28 April 2022

Accor Vacation Club  
The Sebel Darling Harbour, The Pinnacle  
104 Pyrmont Street  
PYRMONT NSW 2009

**Submission in relation to Sydney Metro West – Rail infrastructure, stations, precincts and operations (SSI-22765520)**

**Figure 14-8 Indicative construction sites layout – Pyrmont Station**  
*EIS Figure 14-8, Indicative construction sites layout – Pyrmont Station*

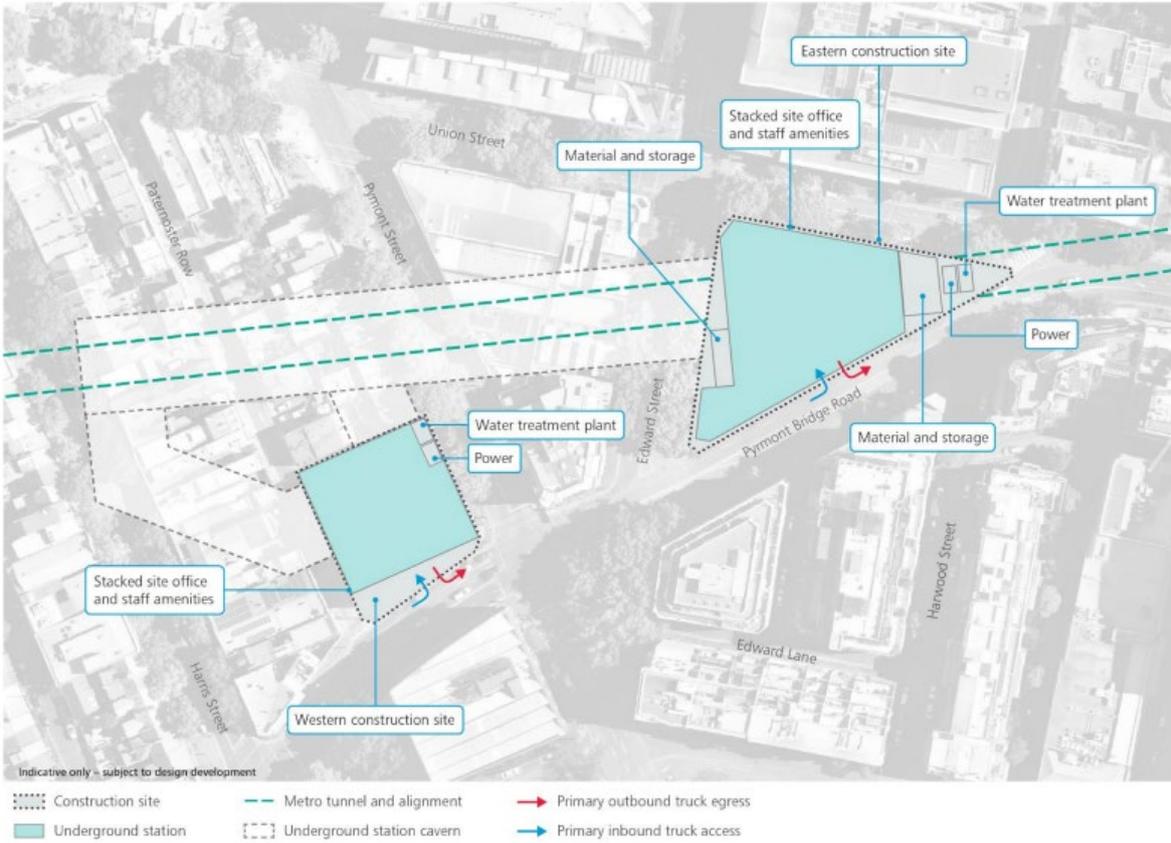
The Sebel is located on the intersection of Pyrmont Street, Pyrmont Bridge Road and Edward Street. As such, **it will be surrounded on both sides by the western and eastern construction sites for the proposed Pyrmont Station**. As depicted in the figure below, the proposed egress routes for the two construction sites cross directly in front of The Sebel. Once operational, the entrances to Pyrmont Station will be located on Pyrmont Bridge Road and Union Street.

- (a) Establish acoustic sheds at both Pyrmont construction sites for the entire duration of proposed construction work;
- (b) Install triple-glazed windows throughout each of the apartments at The Sebel prior to commencement of construction;
- (c) Provide unobstructed access to The Sebel on Pyrmont Street (ie the main entrance) and Edward Street (ie the car park) and all areas leading up to these access points at all times, to guarantee the continuity of its business operations; and
- (d) In recognition of the heightened air quality impacts likely to be experienced at The Sebel by virtue of its location, undertake cleaning of the building and windows, cleaning and servicing of all major equipment and machinery and provide an extended warranty on all such equipment and machinery (in the manner/frequency described in this submission below).

*EIS Figure 14-11, Primary construction haul routes – Pyrmont Station*

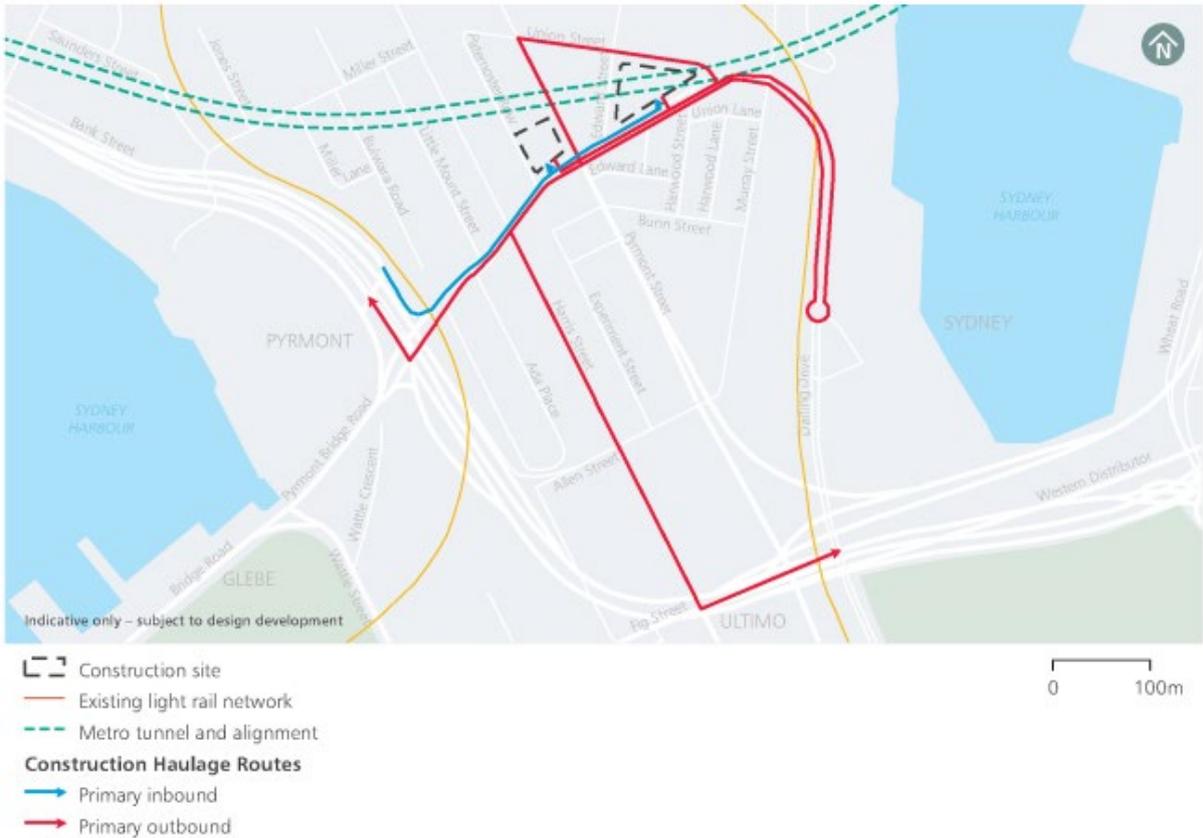
The above traffic impacts, along with noise and vibration, air quality and visual amenity impacts, all have the potential to have a significant impact on The Sebel and APVC Ltd's business during the lengthy construction period of the project, and should therefore be the subject of appropriate and specific mitigation and compensation measures (as discussed further below). To guarantee the continuity of its business operations, APVC Ltd also submits that as a condition of approval Sydney Metro should be required to provide unobstructed access to The Sebel on Pymont Street (ie the main entrance) and Edward Street (ie the car park) and all areas leading up to these access points at all times.
